FLORIDA POWER & LIGHT COMPANY
ST. LUCIE PLANT UNIT 2

CONTAINMENT ISOLATION
VALVE TESTING
SHEET 6
FIGURE 6.2-74

CONTAINMENT ISOLATION
VALVE TESTING
FIGURE 6.2-69

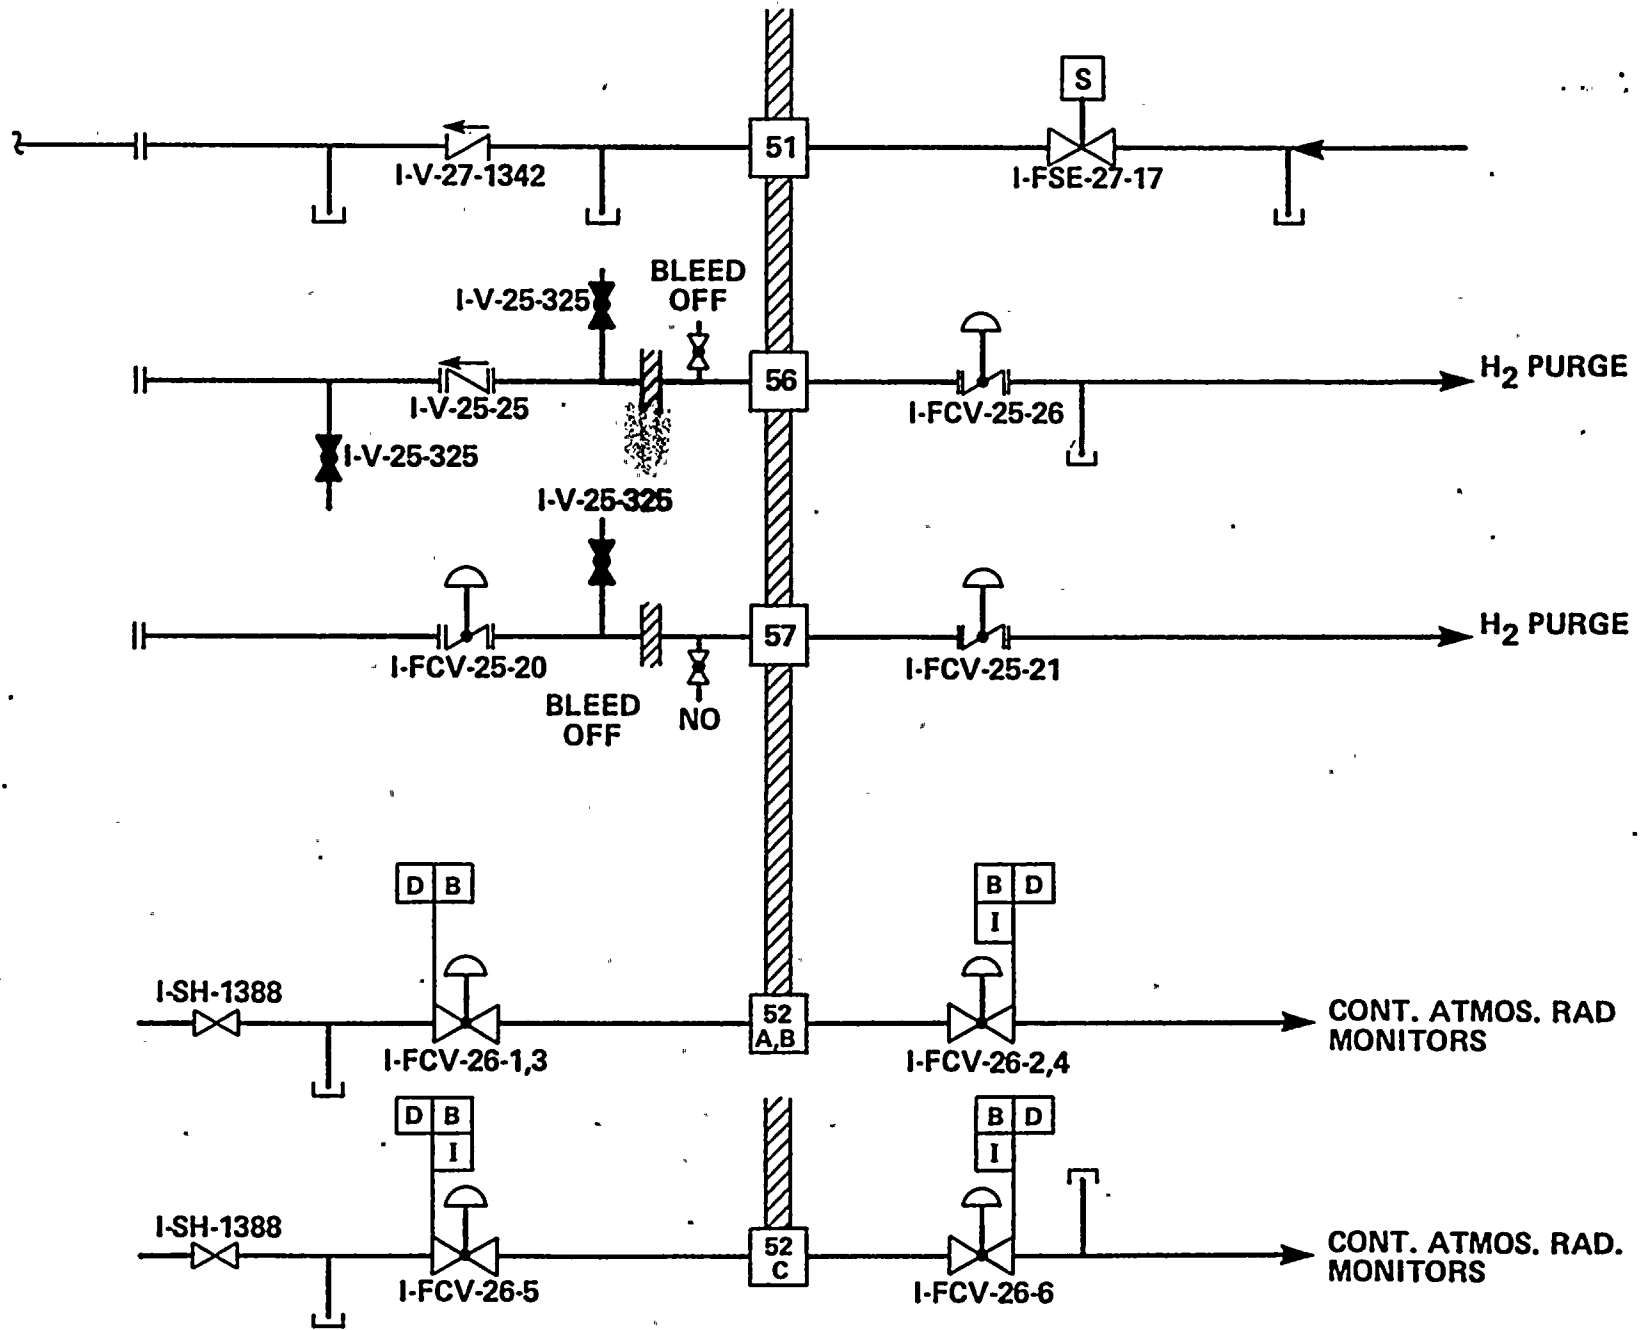
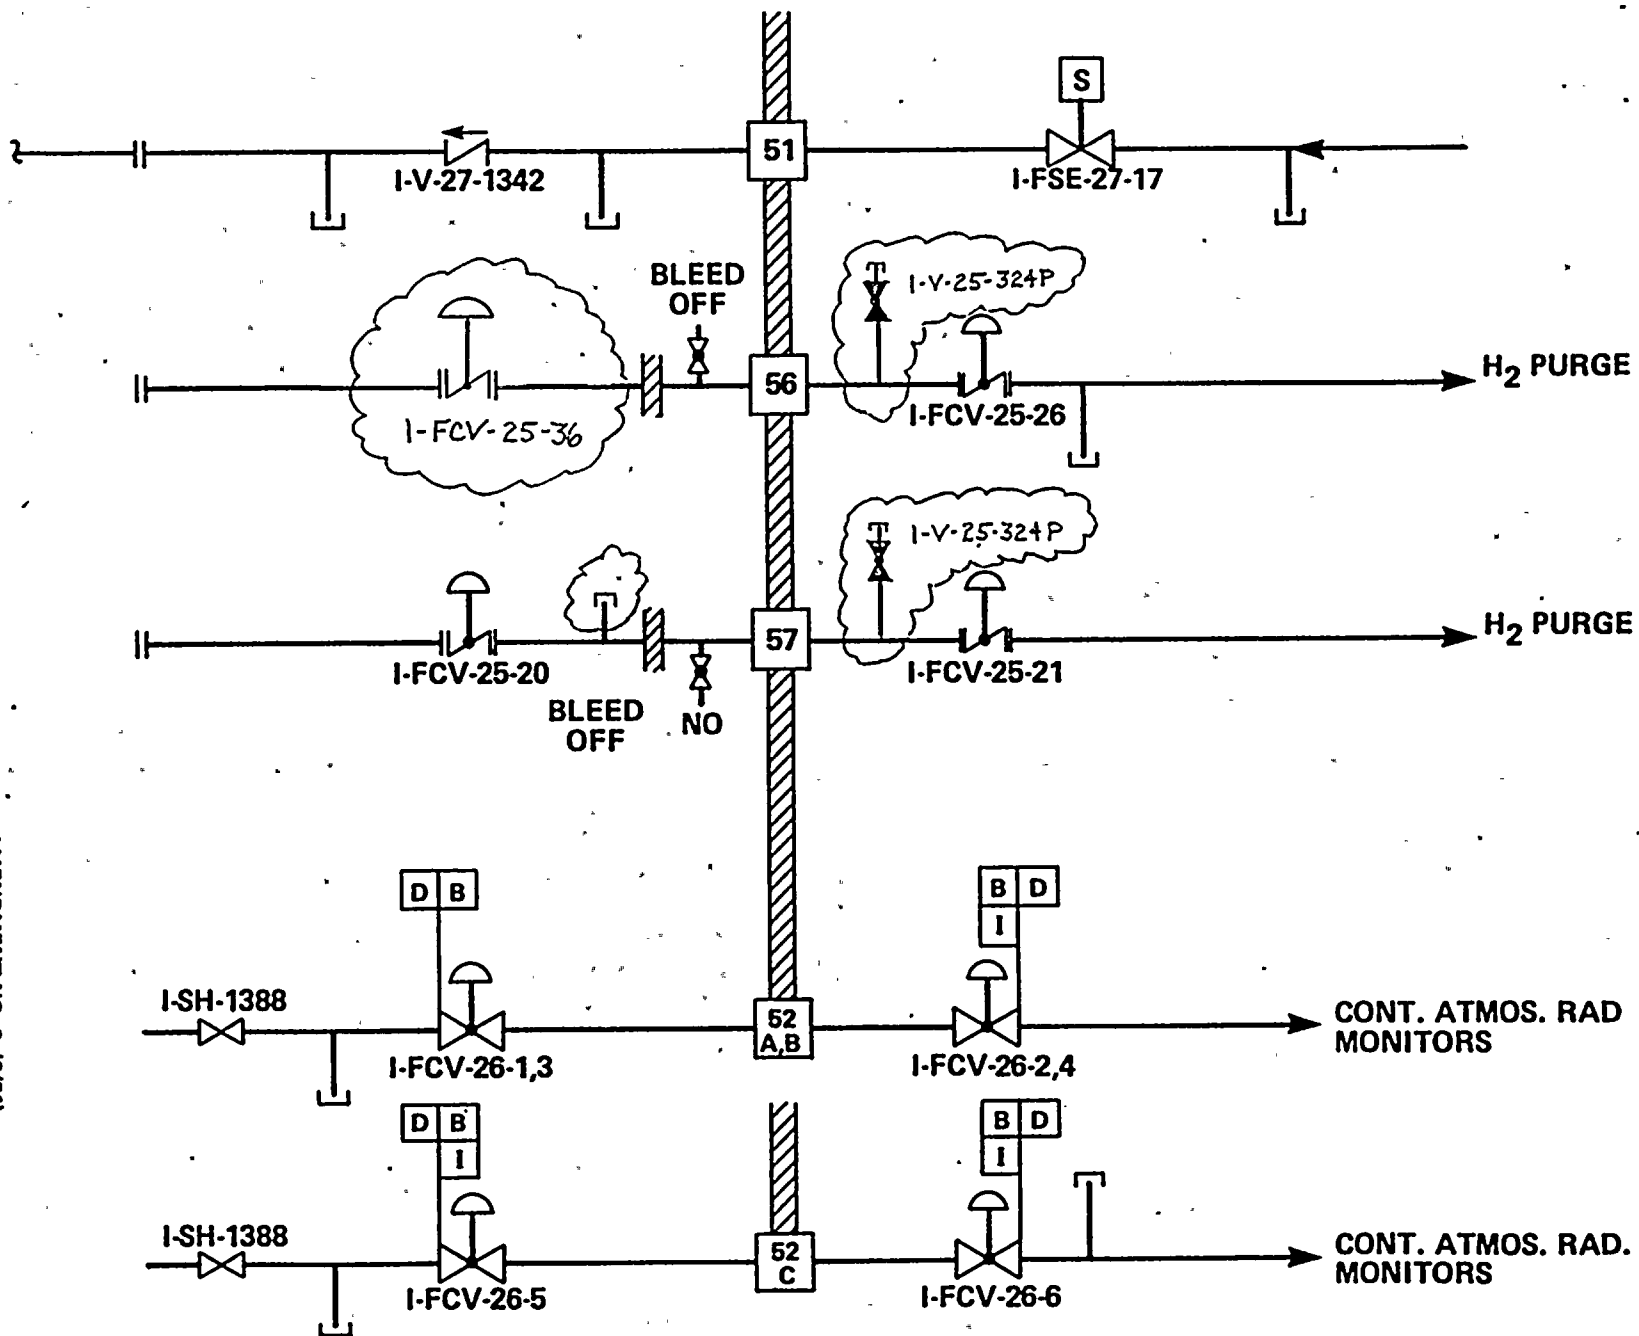
BEFORE
